Attachment 2
Comments and Responses on the Draft Erosion and
Sedimentation Report

FERC No. 2628

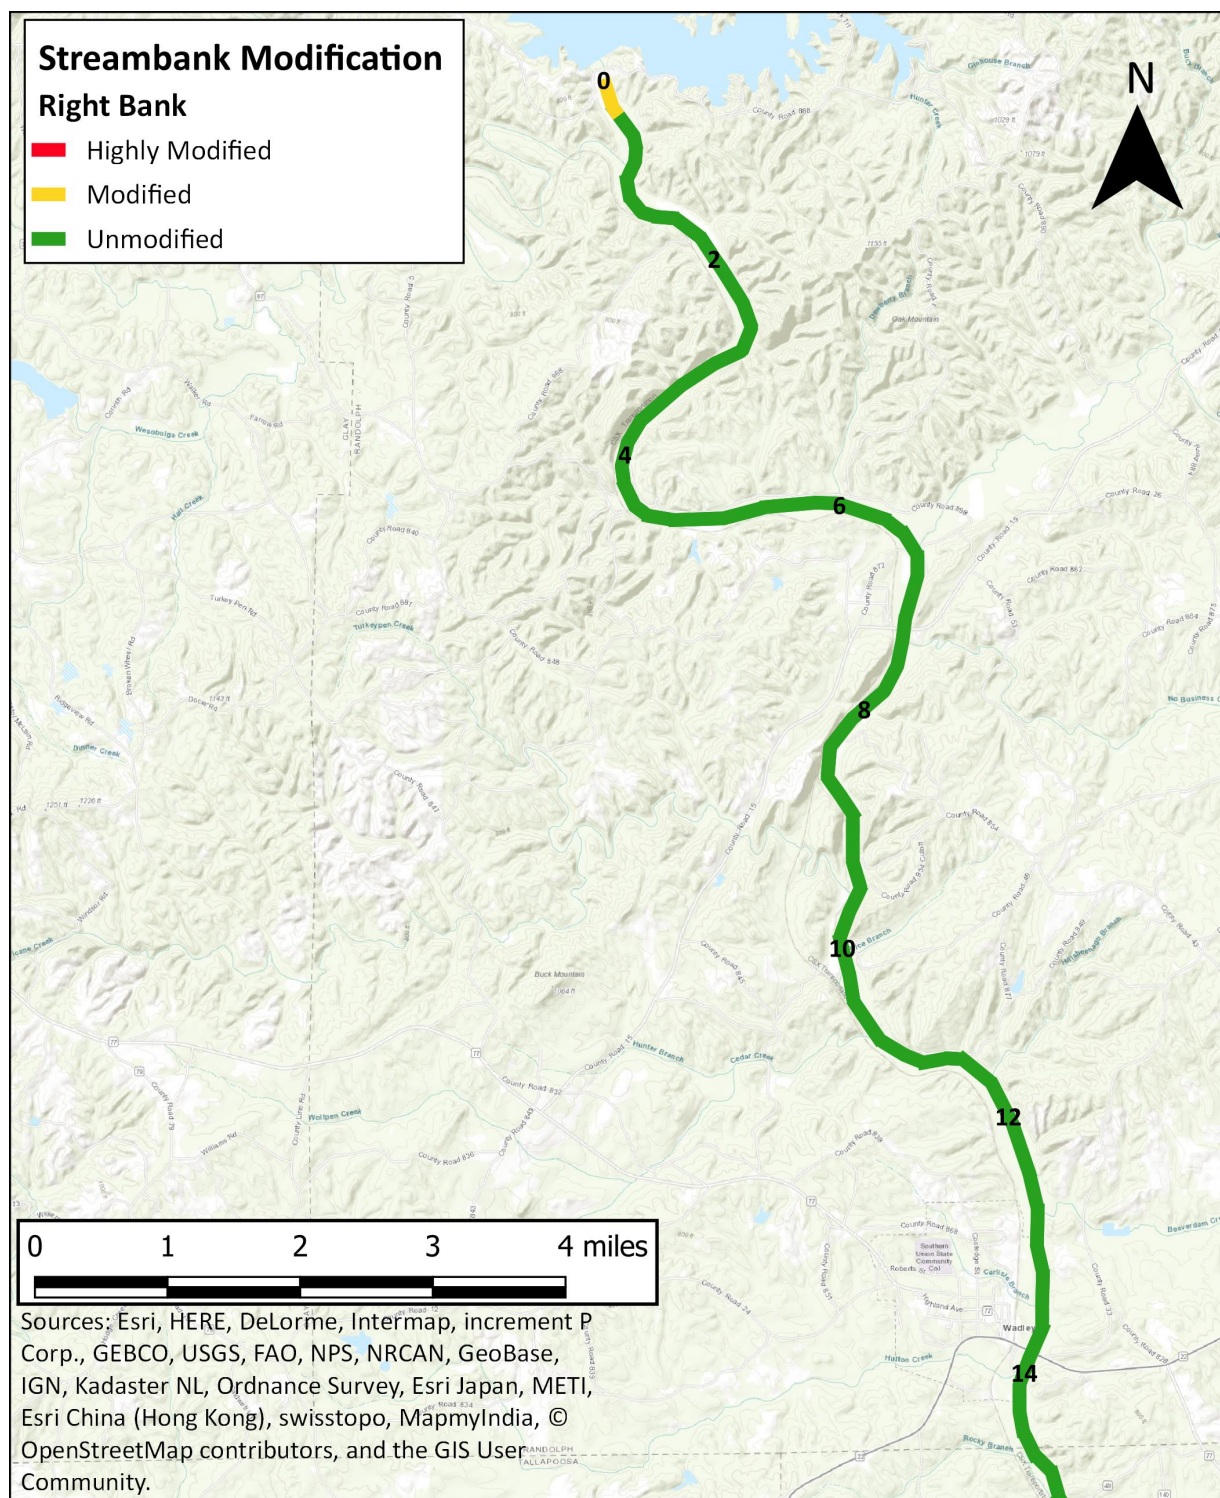
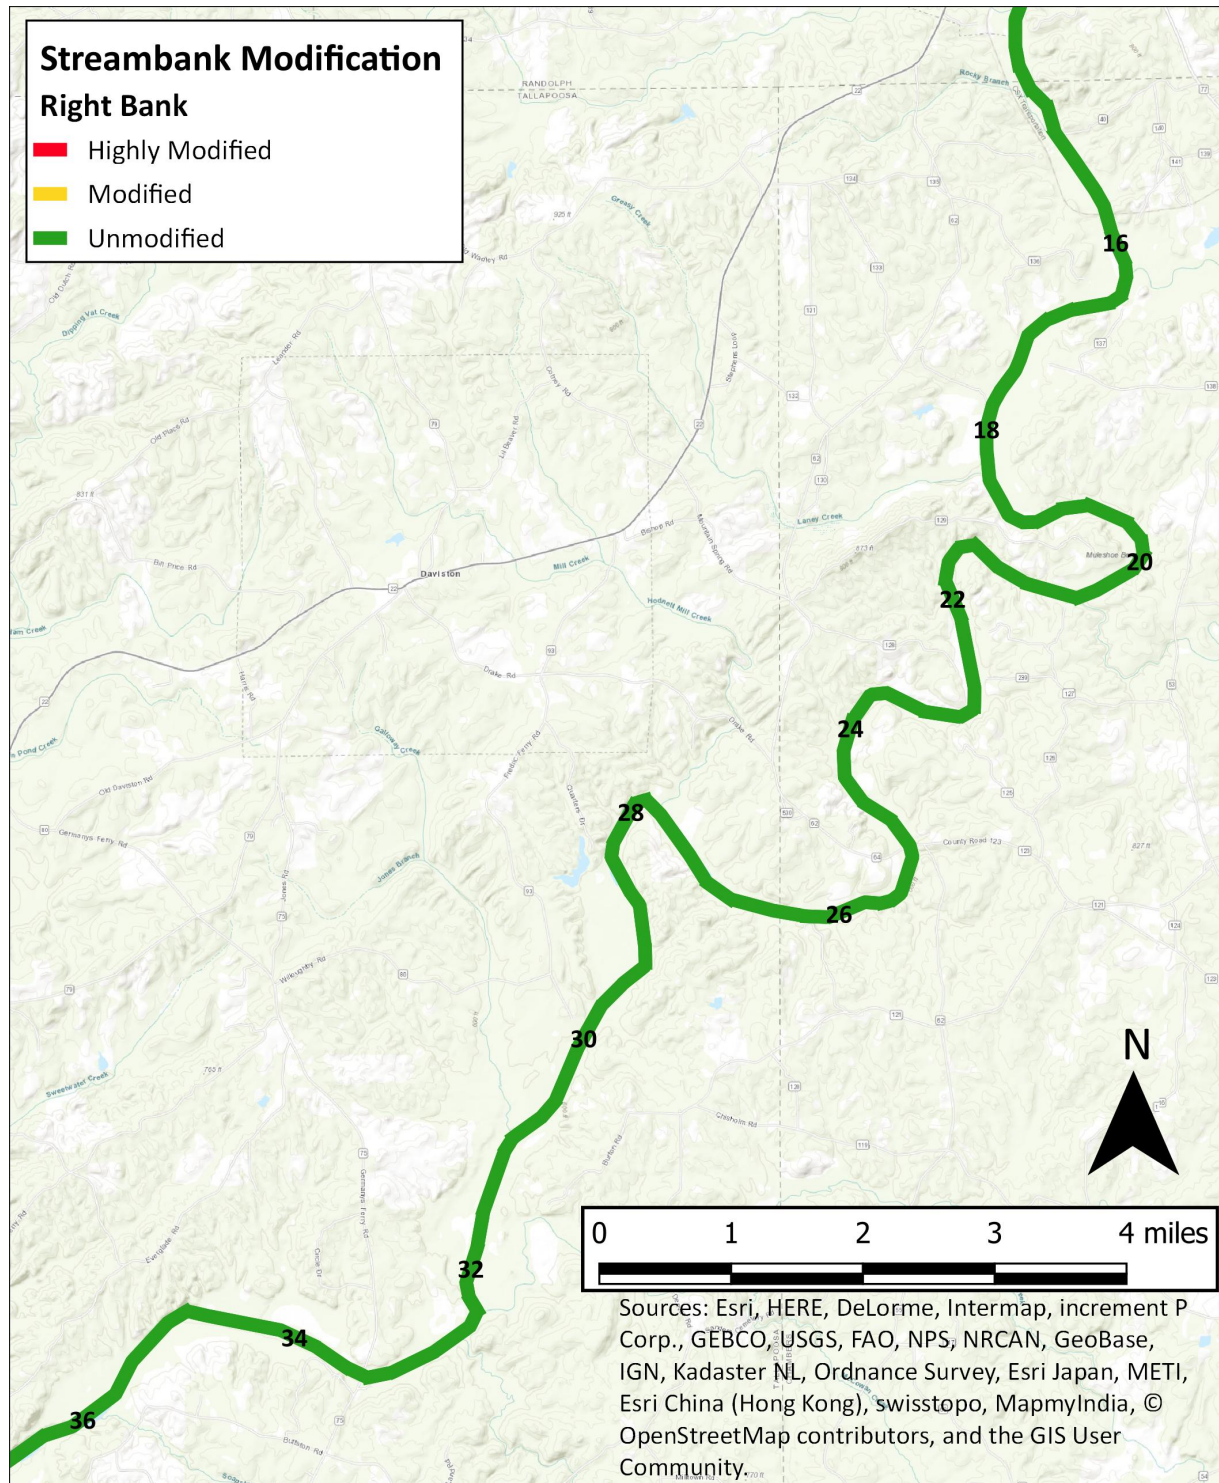
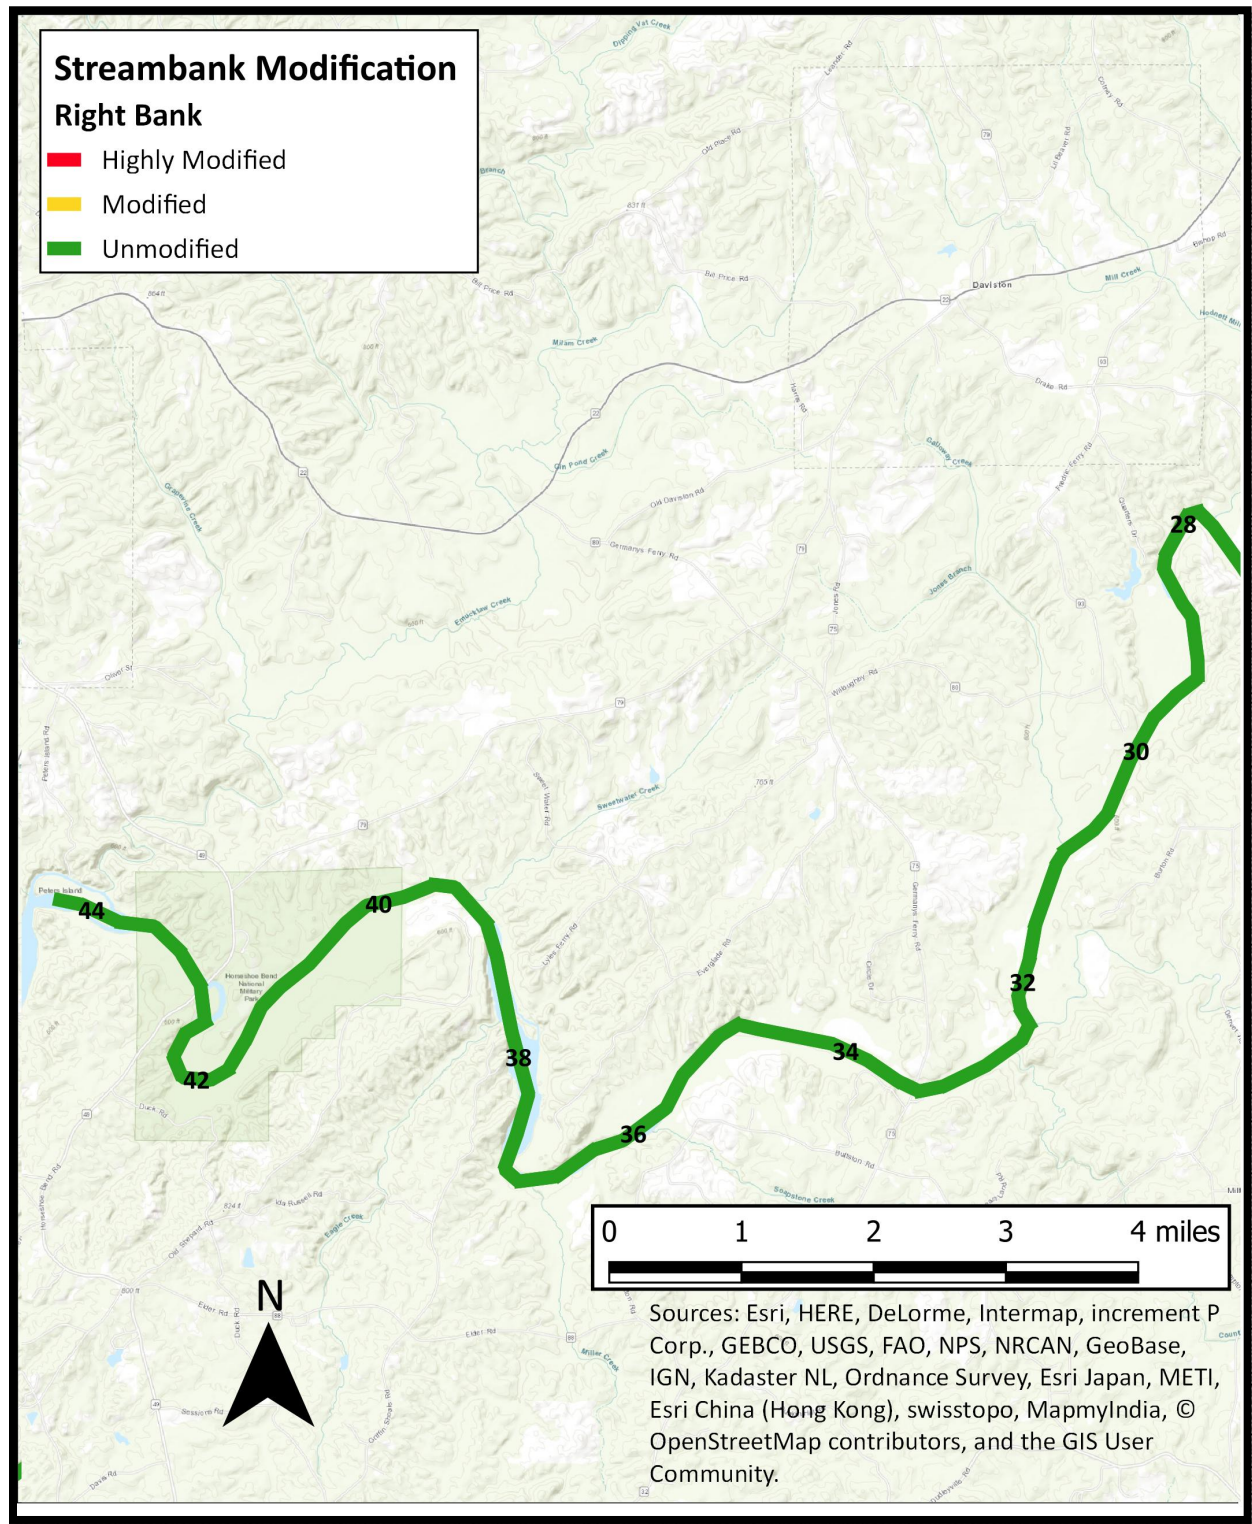
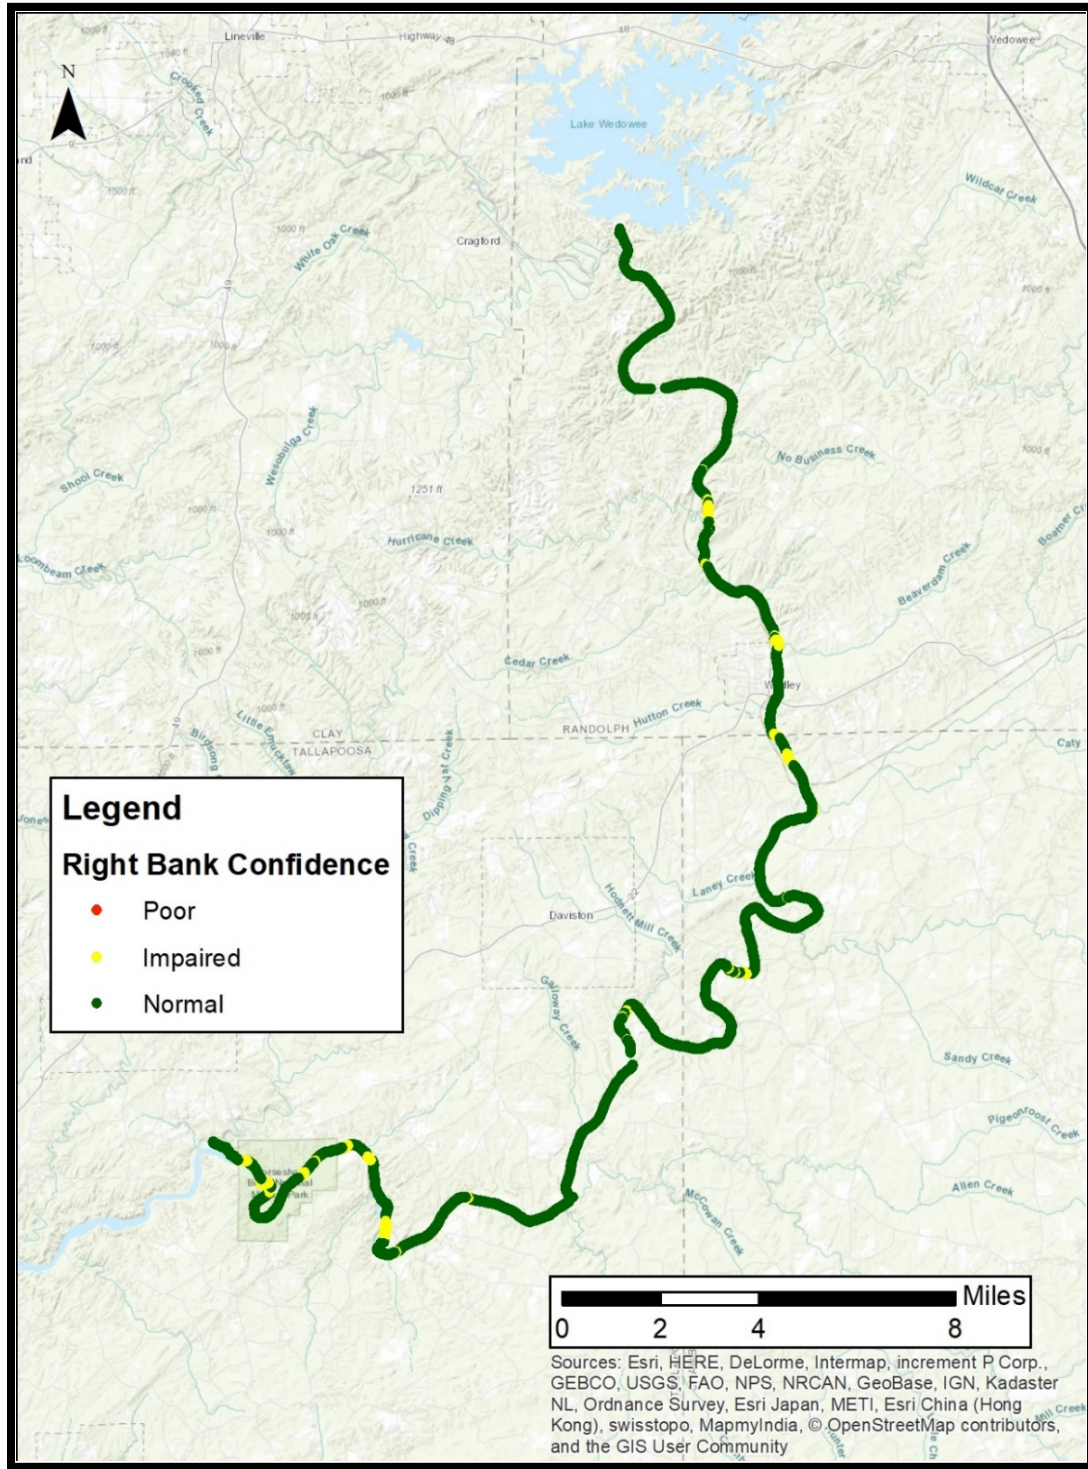
FERC	Questions submitted in advance of 4/28/20 ISR Meeting	For Figures 20 through 23 of the Tallapoosa River High Definition Stream Survey Final Report, please label the river mile ranges on the maps to help reviewers understand the starting and ending points of the study area and which segments of river are included. In Figure 26 of the Tallapoosa River High Definition Stream Survey Final Report, please move the scale bar and sources so that they are not covering the river segment and bank conditions at the bottom of the map	Revised figures are provided in the Tallapoosa River High Definition Stream Survey Final Report (updated December 17, 2020).
